# SUPPLEMENTARY INFORMATION

## To THE WSA WATER SUPPLY CODE OF AUSTRALIA WSA 03:2011-3.1 MRWA Edition Version 2.0 and MRWA Standards

This supplementary information document is an update to version 1.0 of the same document published by Western Water in 2018. All GWW Accredited Consultants, Contractors and approved suppliers shall refer to the current version of this document (V2) as **version 1.0 is no longer applicable within GWW region**.

Figure 3: ACC Valve Cover Marking

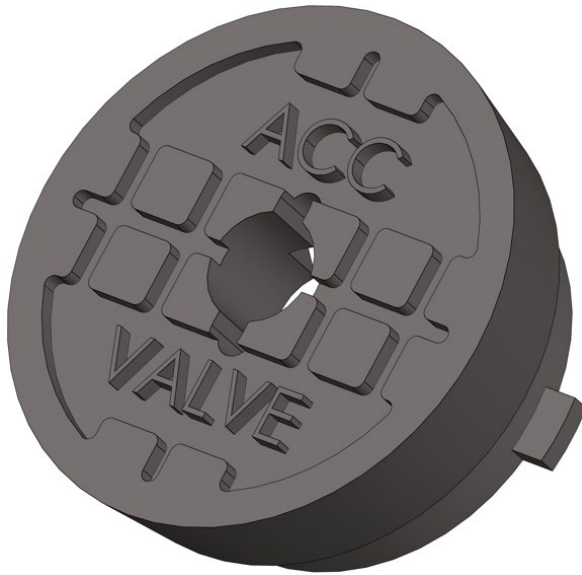
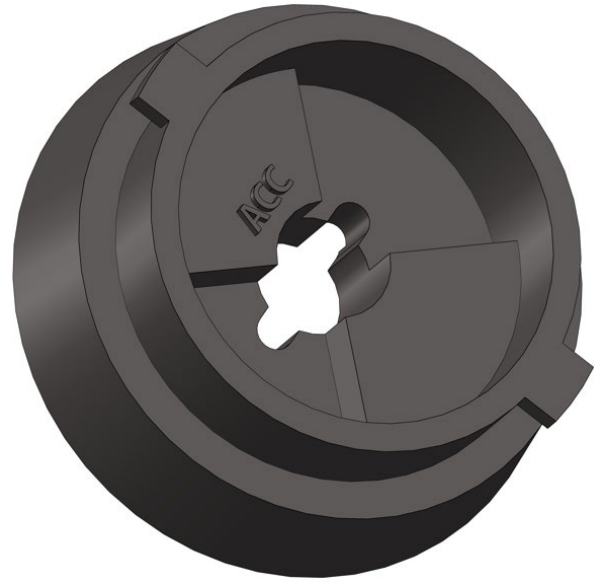
Item#	Subject	Previous Water Supplement (Version 1) – Western region only - No longer applicable	Version 2, applicable to the entire GWW service area
			<p><b>marking "ACC Valve" on the cover shall be casted with the valve cover on both sides (front and back) not as a separate addition.</b></p> <p>These marked covers shall be installed in trafficable and non-trafficable areas (i.e. shall be Class D and Class B). In the event that the above-mentioned covers are not available in the market, the designer/the contractor is required to contact GWW to agree on alternative marking procedures.</p> <p>The installation of ACC marked covers within the Lilac shaded area shown in Figure 2 shall continue until GWW issues a formal instruction in the future advising how the ACC valves should be installed.</p>
